ADDENDUM No.02

CAP24-037-RFP02

Quinte Health BGH – Phase 2 – Generator & Fuel System Replacement Project

July 24, 2026

2.1 Drawing M3-01 – Mechanical Plan – New Work (Re-issued)

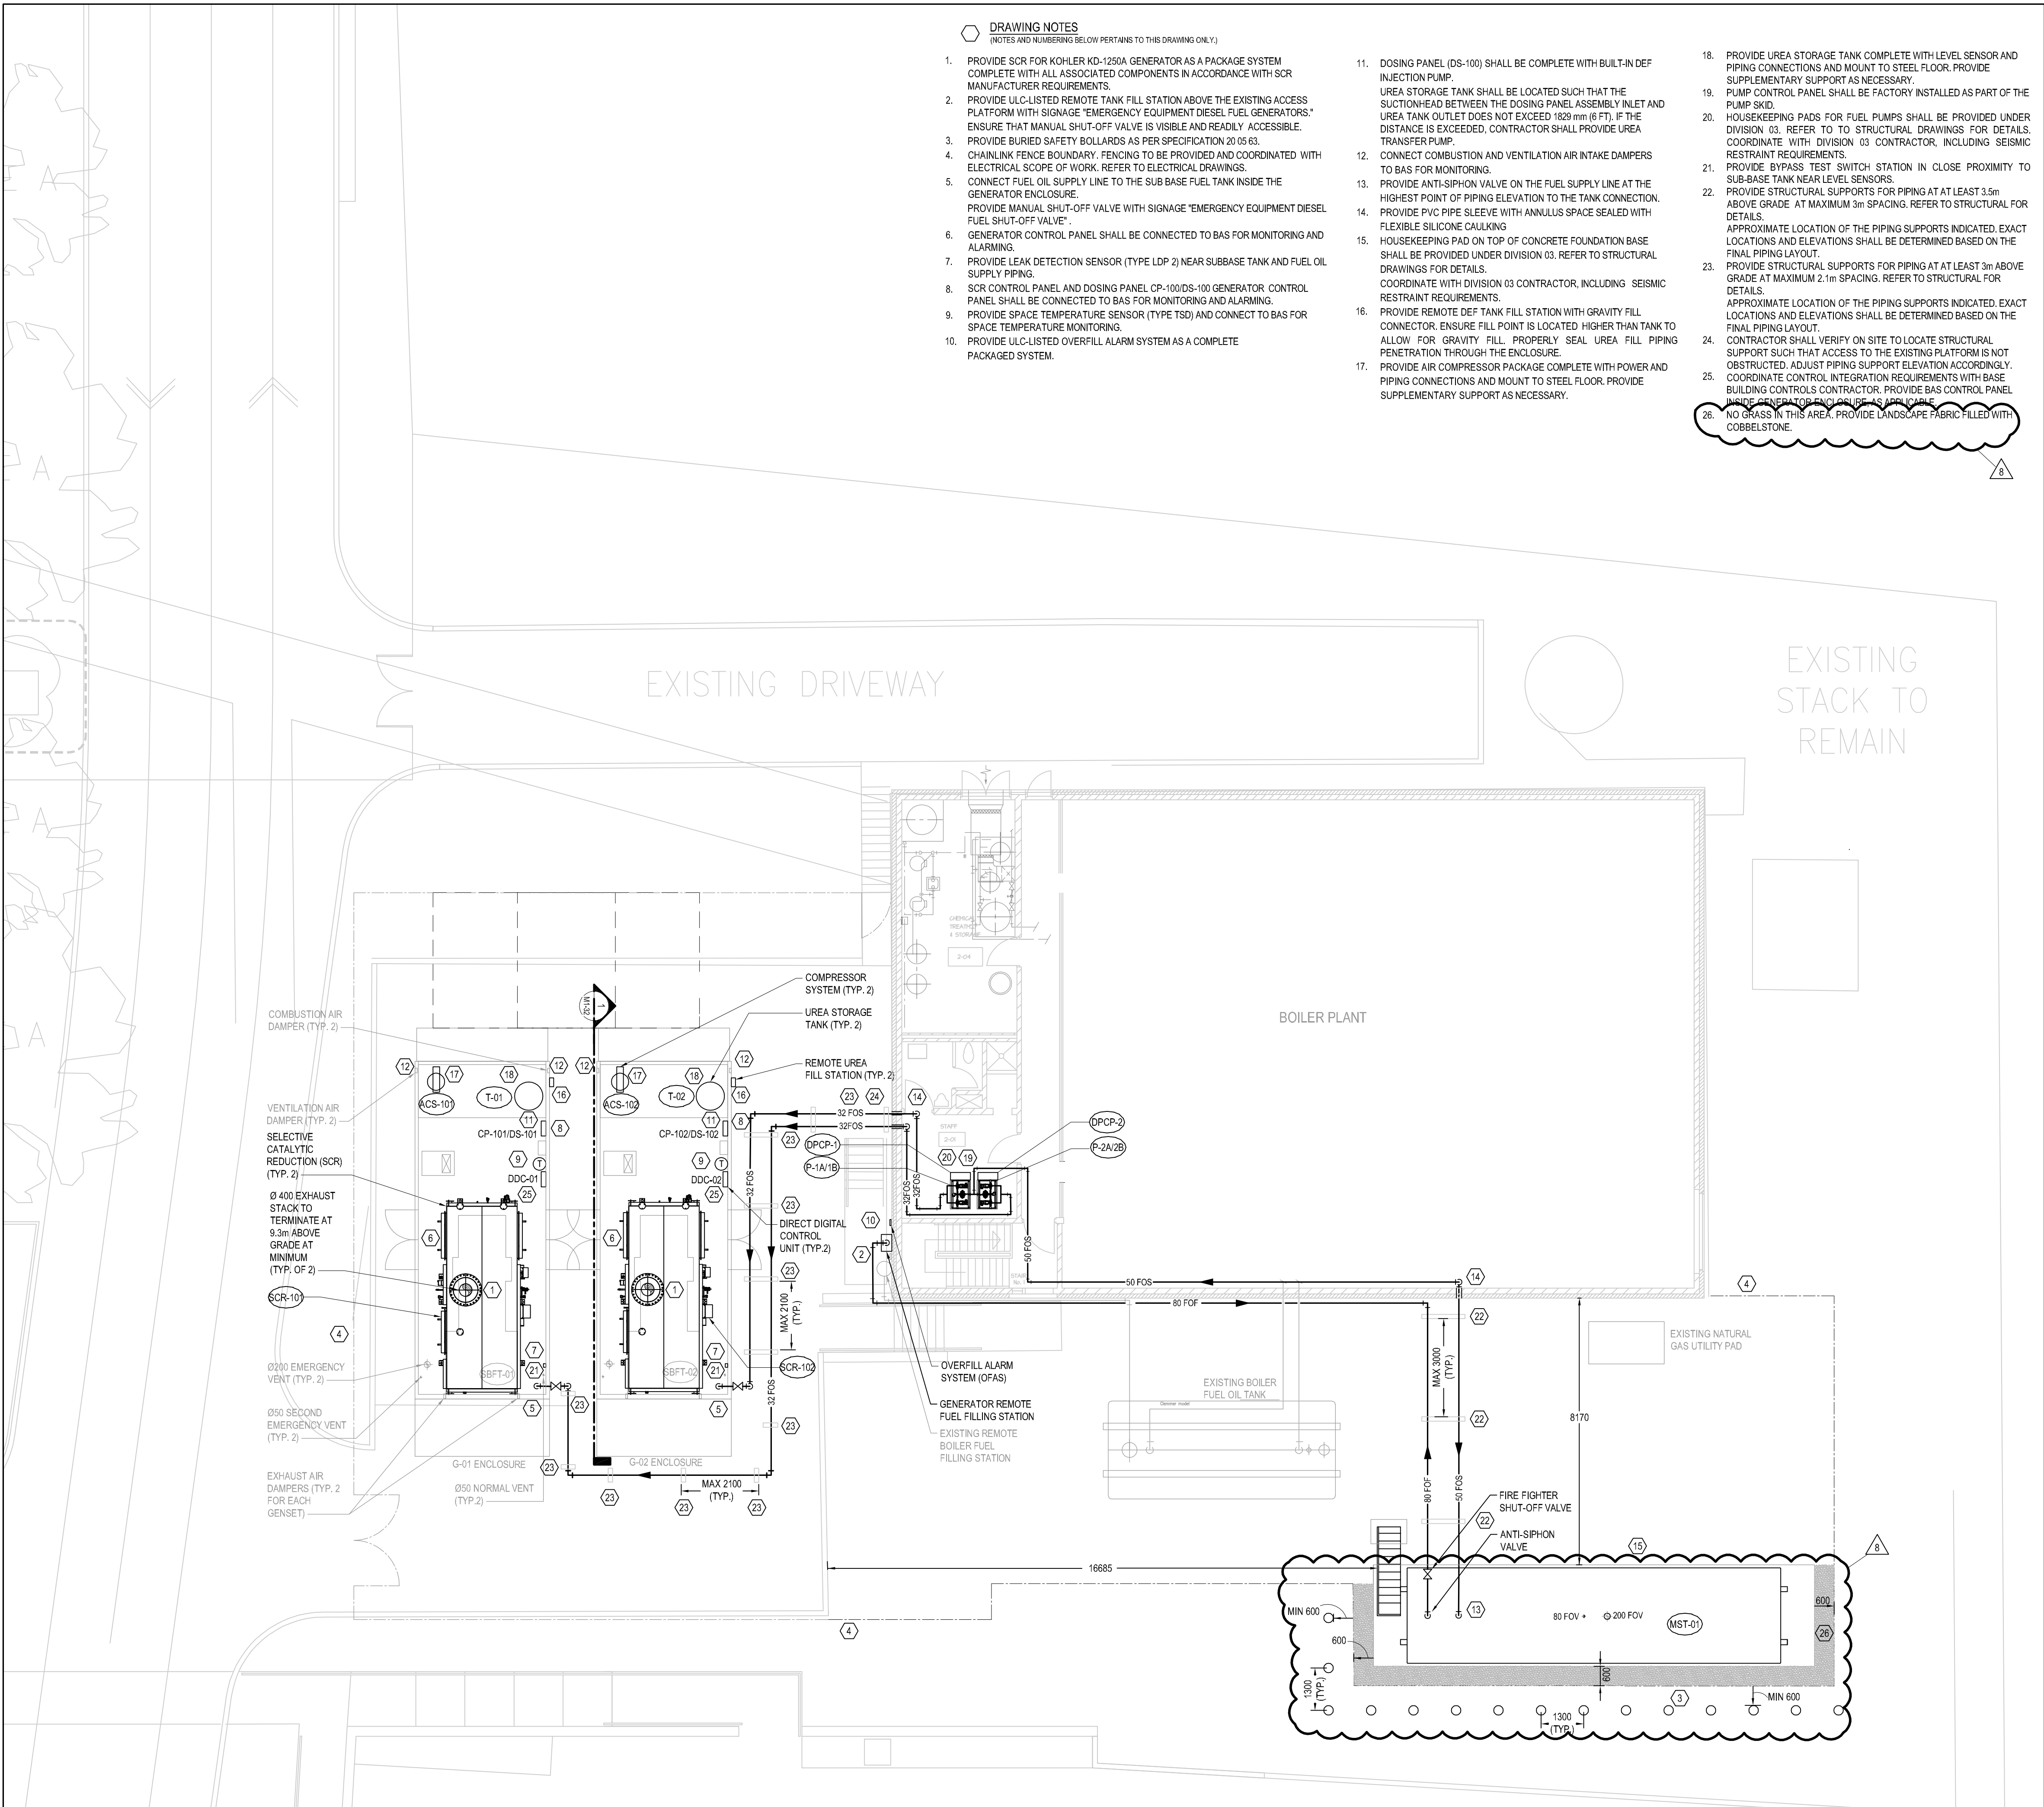
- .1 Landscape near new fuel tank clarified.

2.2 Drawing M9-01 – Mechanical Demolition Sheet-1 (Re-issued)

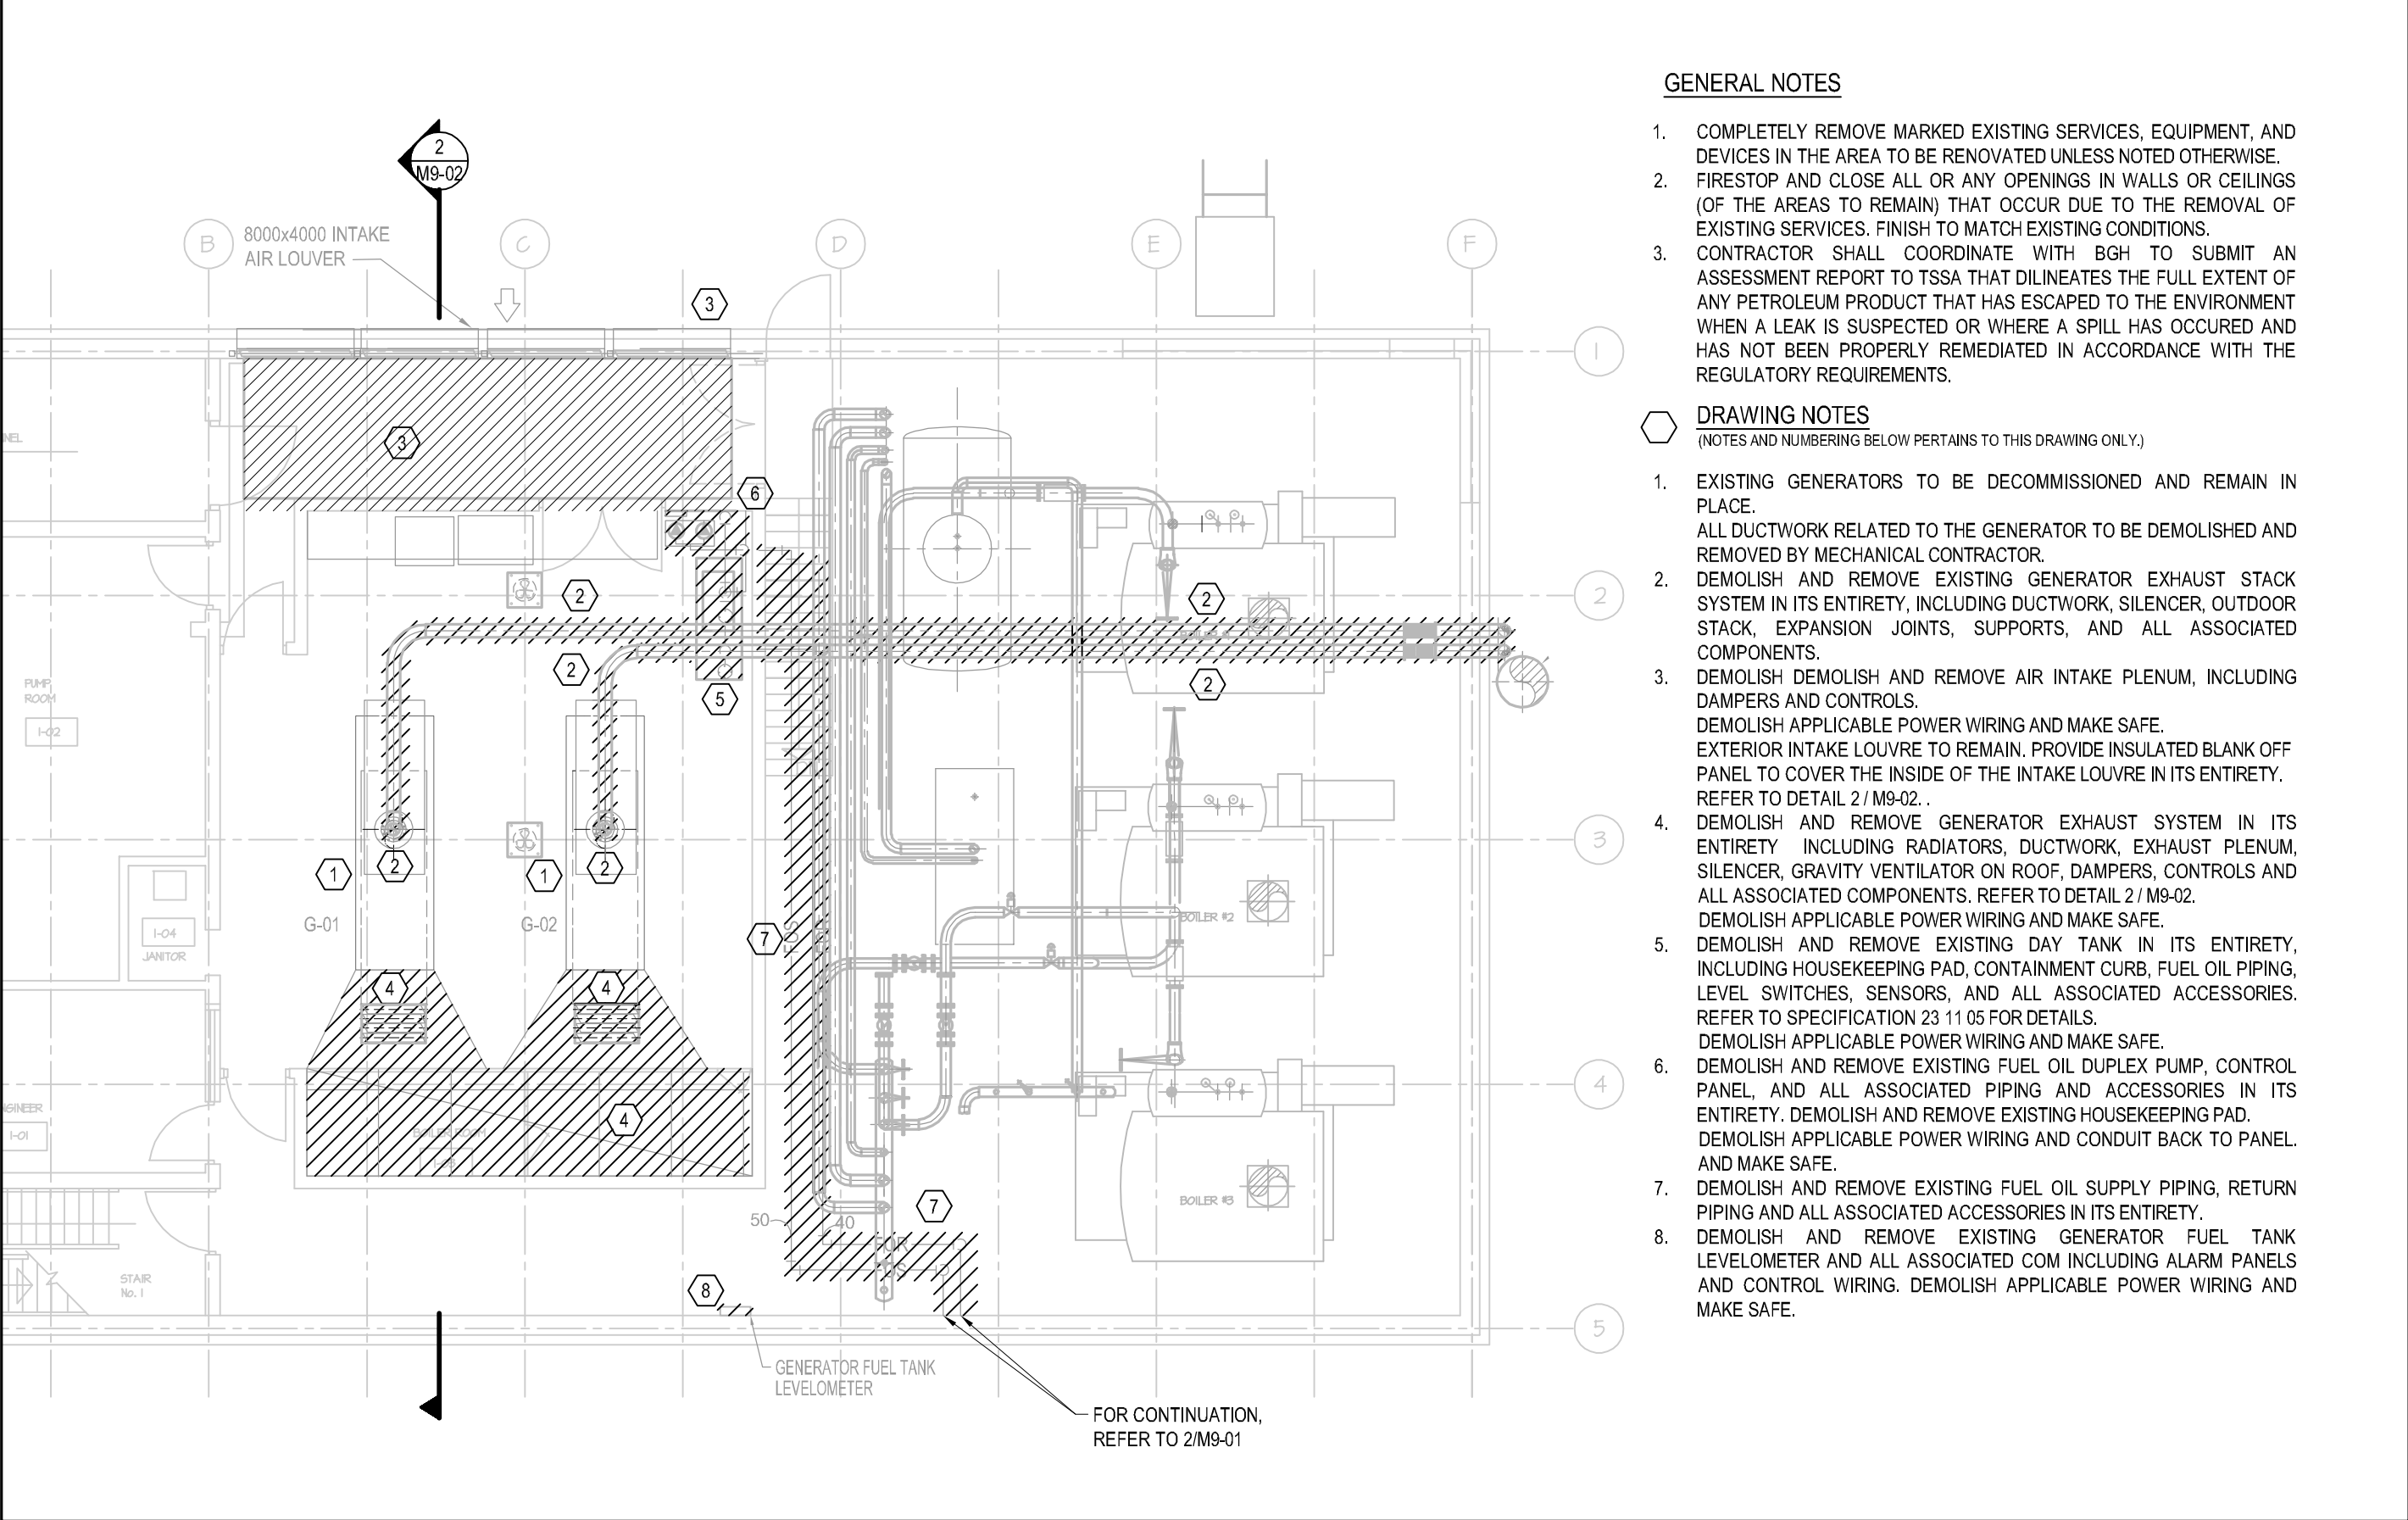
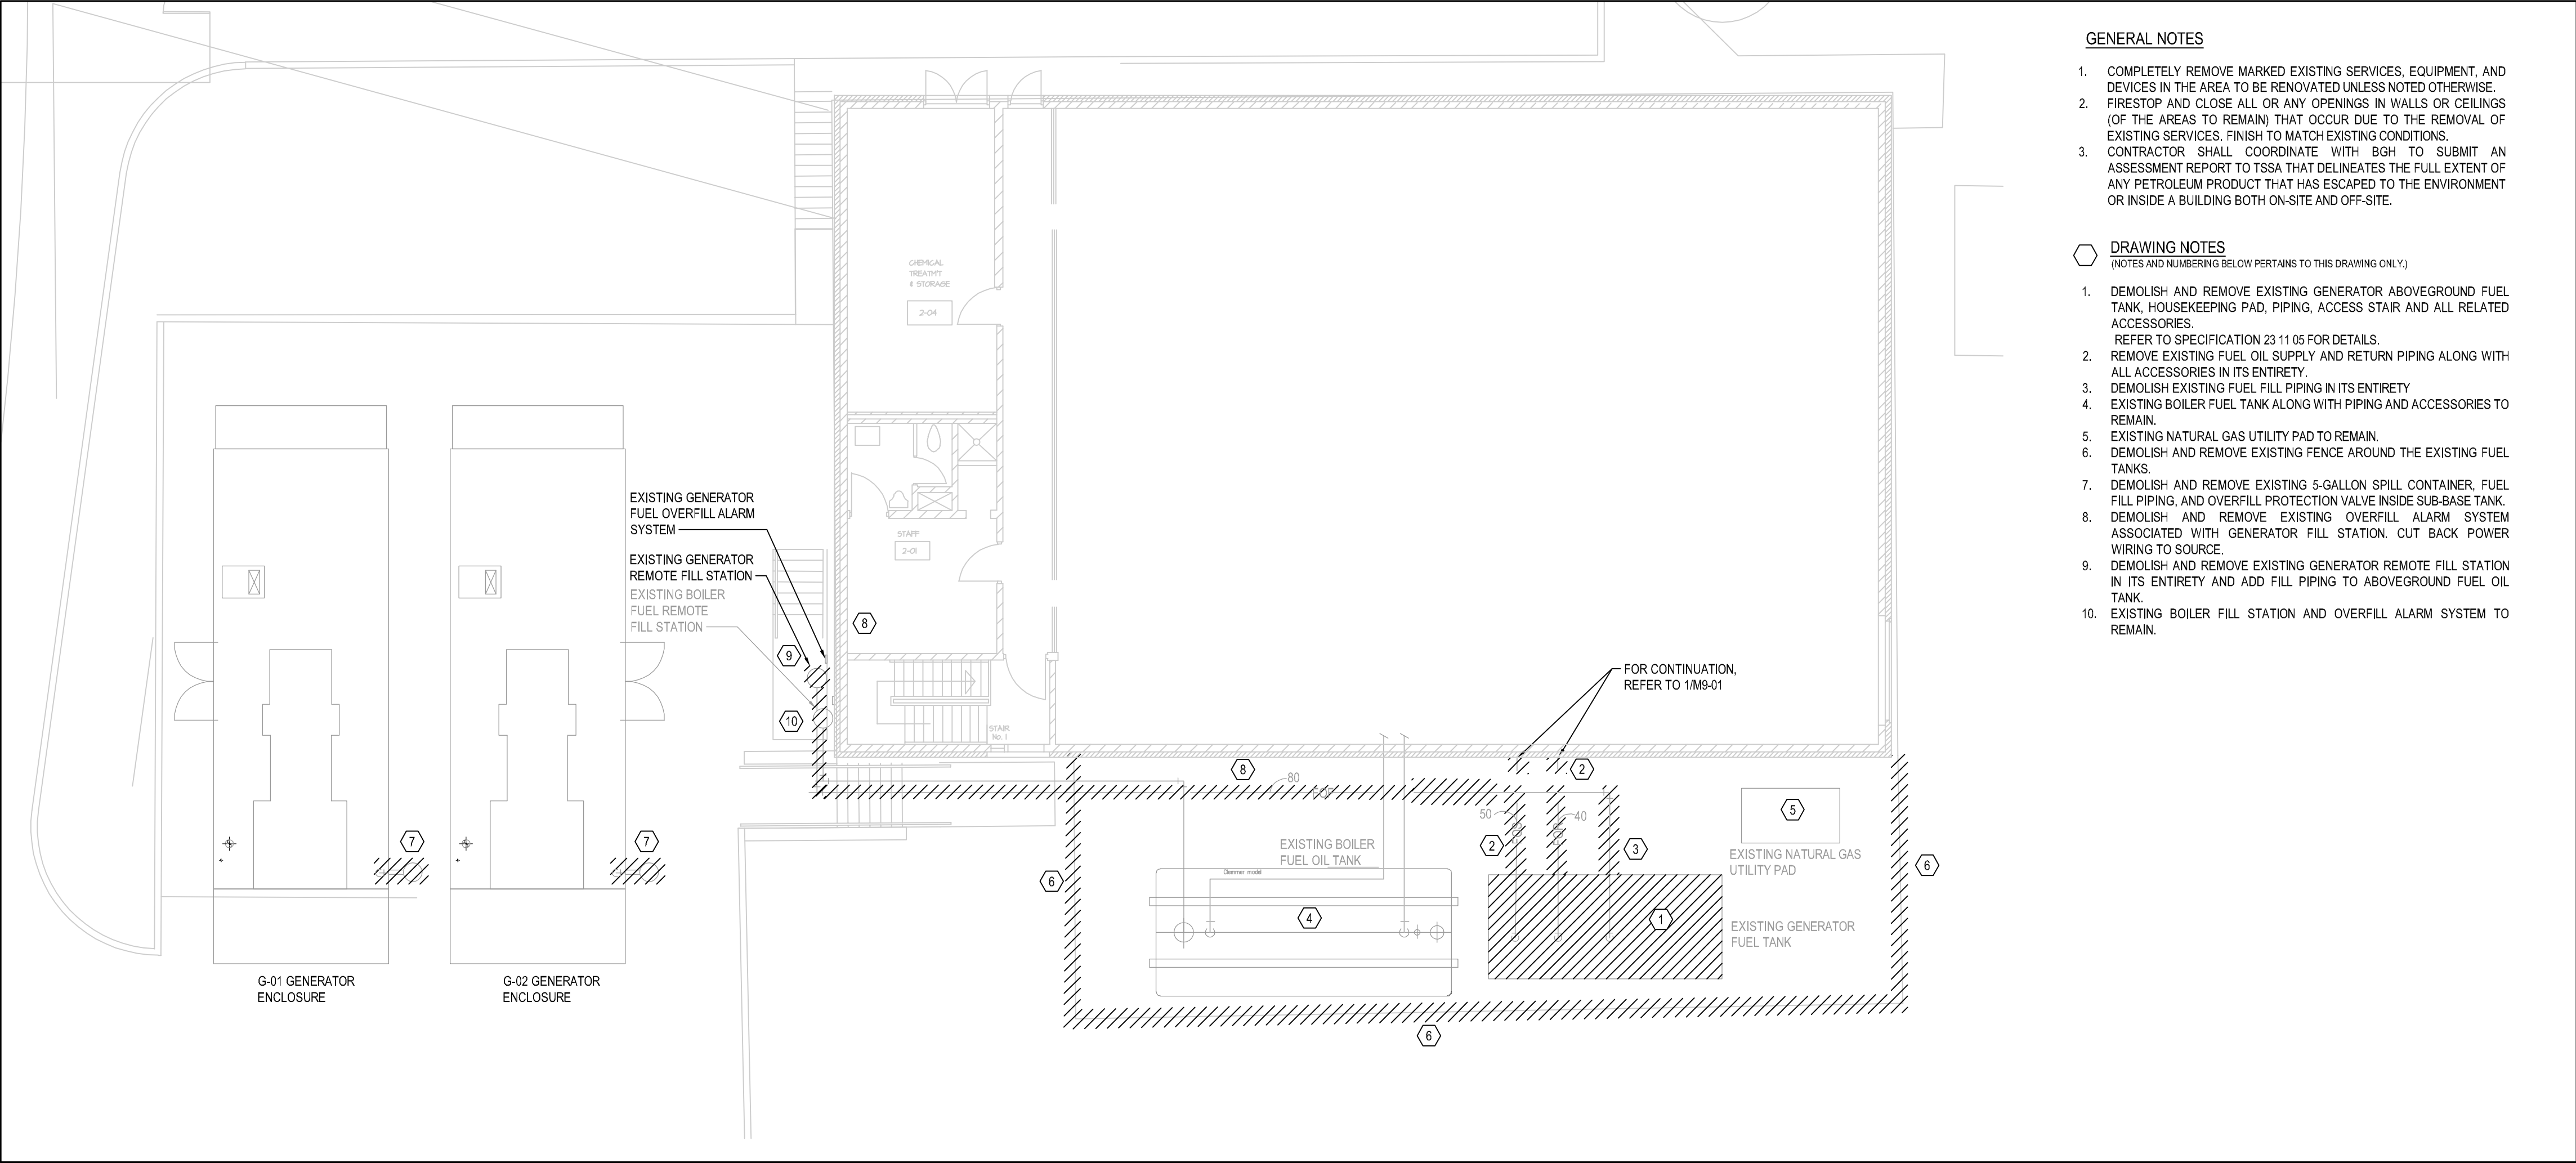
- .1 Demolition scope clarified.
